**Prudence Review of
Newfoundland and Labrador Hydro
Decisions and Actions
Final Report**

Executive Summary

**The Board of Commissioners of Public Utilities of
Newfoundland and Labrador**

The Liberty Consulting Group

Illustration 2.1: LOLH and System Reserves

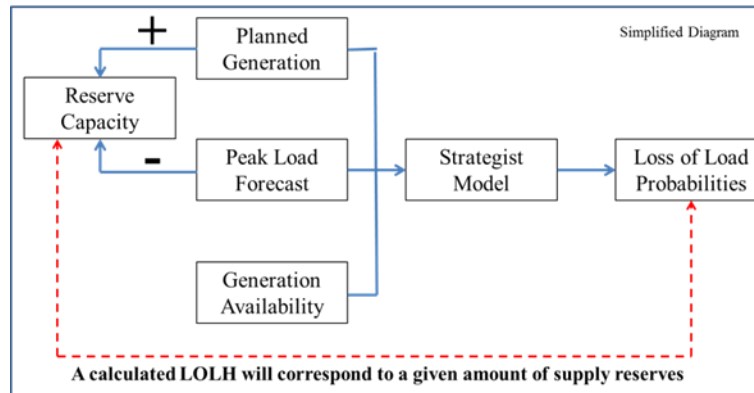
LOLH and reserves have a direct relationship. That relationship changes when the assumptions in the planning model Hydro uses change. For example, the very same LOLH has resulted from reserves that vary across a fairly wide range; *i.e.*, from approximately 12 to 18 percent. Despite the same LOLH, the level of reliability that results from 12 percent versus 18 percent reserves is not likely to be the same.

Generally, one can more readily understand reliability in terms of reserves, as opposed to LOLH. Moreover, from a simple common sense perspective, reserves can prove more material. For example, consider the case where 200 MW of reserves serves to meet maximum acceptable LOLH. If such a company, like Hydro, has a largest unit of 175 MW, the loss of that unit would leave the system on the edge of shortages. LOLH may reflect a more sophisticated approach, but not necessarily one that proves conclusive. Using an LOLH calculation certainly reflects good practice. Good planning, however, also requires examination of the reserve levels that result, in relation to the kinds of supply contingencies that merit consideration.

The failure to address reserves in this manner comprises a shortcoming in the Hydro supply planning processes. We also have concern about the lack of reserve-level transparency. For example, testimony in Hydro's general rate proceedings in 2001, 2003 and 2007 indicated reserve levels had decreased from 18 to 15 percent in this time period. The Company provided no additional information to stakeholders on reserves until their state became apparent during analyses associated with the 2014 outage investigation.

Liberty found the lack of focus on reserves to be problematic, but not to a level that we believe is required to meet the standard for imprudence. Hydro has followed a consistent approach to supply planning for many years. Until recently, the Company has not applied new criteria, techniques, approaches, insights, or significant changes of any kind. Hydro has also consistently reported on its processes in its regulatory proceedings, with language describing the processes remaining constant. A number of consultants, including ones retained by the Board, reported no issues following examination of Hydro's LOLH criteria. It should be noted however, that the reserves were 18 percent when last reviewed by the Board's consultant in 1999. While

Table 2.2: Simple Cycle CT Construction Costs

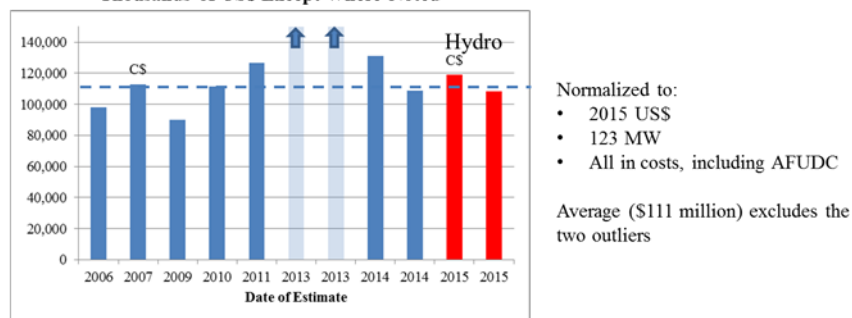
The Holyrood costs appear to be well in line with the EIA expectations.

Liberty also considered seven additional data points in addition to the EIA plants. These plants were located throughout the US and British Columbia. The complete population, shown in the preceding table, confirms the competitiveness of the Holyrood CT. Holyrood’s costs fall just under the average (the table’s dashed horizontal line).

Liberty found no reason to question the reasonableness of the costs of the new Holyrood CT.

Figure 3.2: MW Unavailable

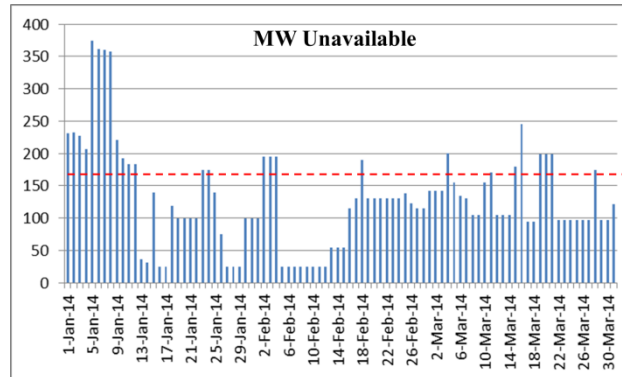
After the extraordinary first 12 days of the month, the extreme levels of unavailability and high replacement costs did not recur. Numerous examples of higher than expected unavailability, lower than expected temperatures, and higher supply costs, however, did occur. Hydro attributes the higher supply costs in the post-event period to lower unit availability and more severe weather. The next figure shows the amount of capacity unavailable on each day in the first quarter. The dotted line denotes the equivalent of the loss of the largest unit (170 MW). Such a

loss places the system in a position where another significant contingency could potentially produce a loss of load. This condition existed on an additional 13 days in the quarter. This seems high and warrants further study.

A breakdown of the 13 days shows that essentially all of the high replacement costs (90 percent) resulted in only three days (shaded in the next table). Two major factors outside Hydro's control occurred on those days; *i.e.*, very cold weather and the unavailability of CBP&P additional capacity for two of the three days.

Figure 3.4: Daily Low Temperature

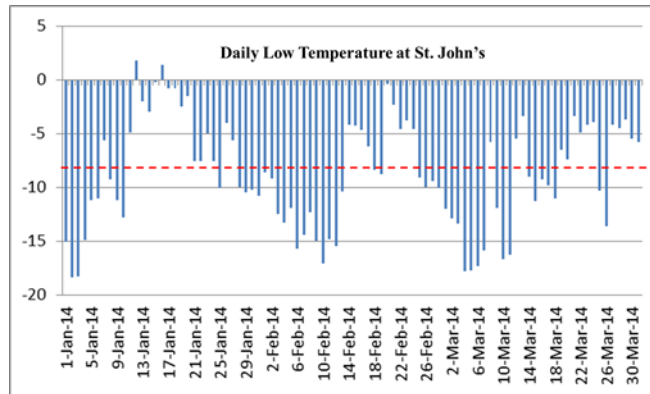
We next examine the effect of weather. The next chart denotes -8°C with a dotted line. When considering the worst temperature in each of the last 30 years, -8°C is the average of the worst annual temperature over those 30 years.⁹ Note that this is not the temperature variable used for planning purposes. That variable incorporates wind chill. Wind chill data was not available for this analysis. Given that the -8°C average is a worst case in each year considered, it would be statistically unusual to expect to see it develop on more than a few days in any given year. Yet the chart is clear; in the post-event period for the balance of the first quarter (78 days), the temperature was lower than -8°C on 50 days.

One can clearly describe such circumstances as extraordinary. When considering costs during the post-event period, it is not surprising that the majority of such costs occurred on the low temperature days, as shown below.

Illustration 10.1: Black Start Chronology

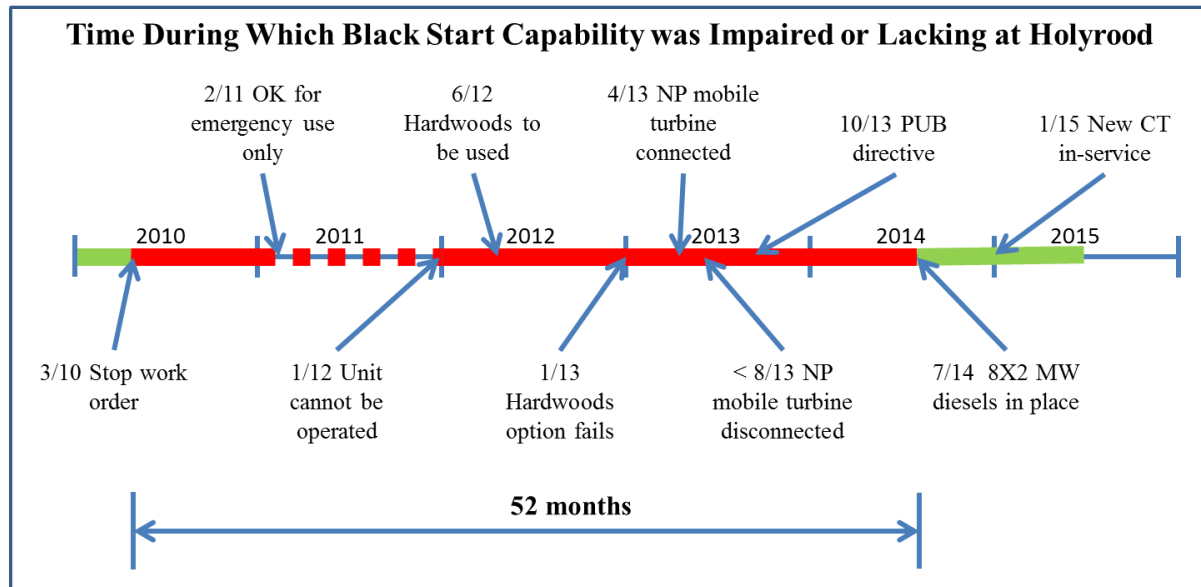
The next illustration shows the periods during which Holyrood lacked or had only impaired black start capability prior to completing installation of the eight diesel generators. The illustration shows how long it took Hydro to succeed in providing black start capability that could work.

Hydro has stated that it believes that the winter of 2010-2011 comprises the only time when it lacked black start capability at Holyrood. Hydro has also stated that:

Map 10.2: Holyrood to Hardwoods Distance

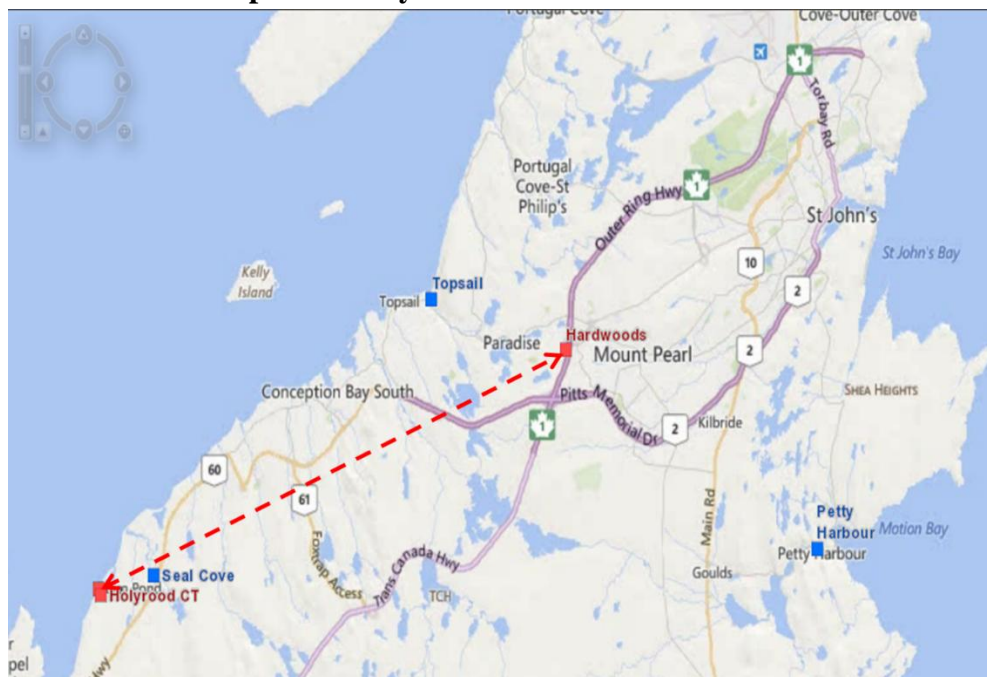
For emergency planning purposes, this isolated area of the system was considered the broader Avalon Peninsula area and not an isolated area adjacent to the Holyrood plant.

The next map illustrates the degree of geographic proximity between Holyrood and Hardwoods.

Liberty found troubling the shift in definition of black start. Consider the North American Electric Reliability Corporation's (NERC) definition of a black start resource:

Diagram 11.1: Evolution of Motor Repairs

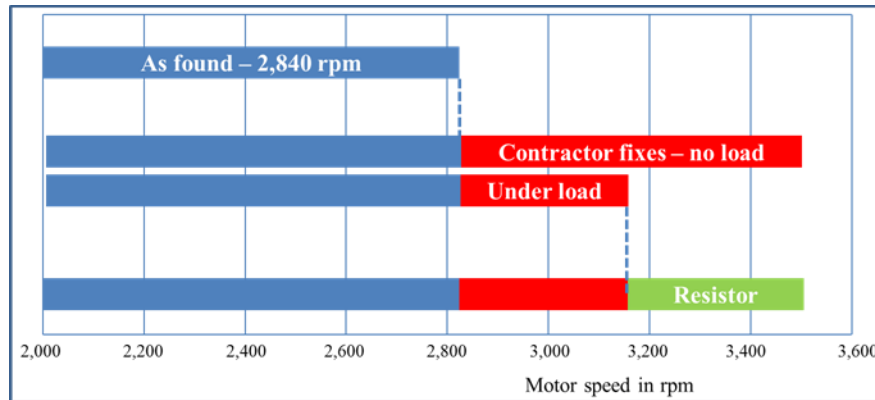
In an effort to determine the cause of the motor's inadequacy, Hydro sent it to a contractor for testing. The contractor also could not attain a speed of more than about 2,800 rpm. Further testing found that: (a) the motor's brush boxes were offset, and (b) the motor's neutral plane was misaligned. The accompanying insert explains how such flaws affected the motor. After the contractor corrected both items, the motor was able to reach its rated speed of 3,500 rpm under no load conditions. After its return to the Plant, Hydro connected the motor to the pump, but it again was unable to come to speed, reaching only about 3,100 rpm. Subsequent adjustment of a resistor setting allowed the motor successfully to reach rated speed under load. The next diagram illustrates this evolution.

The root cause analysis addressed the source of these problems, which appear about equally responsible for the motor's failure to perform. The root cause analysis attributed the misalignments to quality issues at a maintenance vendor, indicating that the resistor setting "was moved." Hydro has stated that the maintenance vendor operated under a standard that required speed testing of the motor before its return. Hydro also states that the vendor did perform the required testing. However, neither Hydro nor the vendor provided documentation sufficient to verify the conduct of speed testing. Hydro recently submitted a copy of the vendor's invoice, which under the description of the work, included the following notation:⁷¹

Chart 13.1: Reported Fires at Isolated System Plants

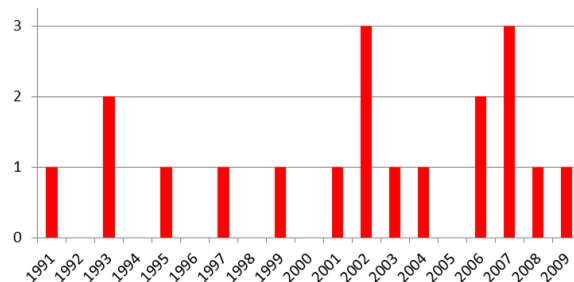
In 2011, Hydro commissioned a study by an external consultant to revisit its approach of not providing fire suppression for such systems.⁹² That study produced a risk matrix and plan for a long term effort to phase in fire suppression systems at the isolated plants. The study noted, as the next chart illustrates, a significant number of fires (19) at isolated systems since 1991.

Moreover, the study cited the possibility of others that may have gone unreported.⁹³ A rate of roughly one fire per year, with some producing catastrophic damage, would suggest that revisiting the fire suppression study was overdue. Hydro's root cause analysis of a 2008 event appears to have triggered the outside study. It is not clear why it came three years later. Liberty believes that it would have been appropriate for Hydro to have addressed the frequent rate of fires earlier. Its isolated systems had experienced 10 fires in the six-year period (2002-07) preceding the 2008 event that led to the 2011 study.
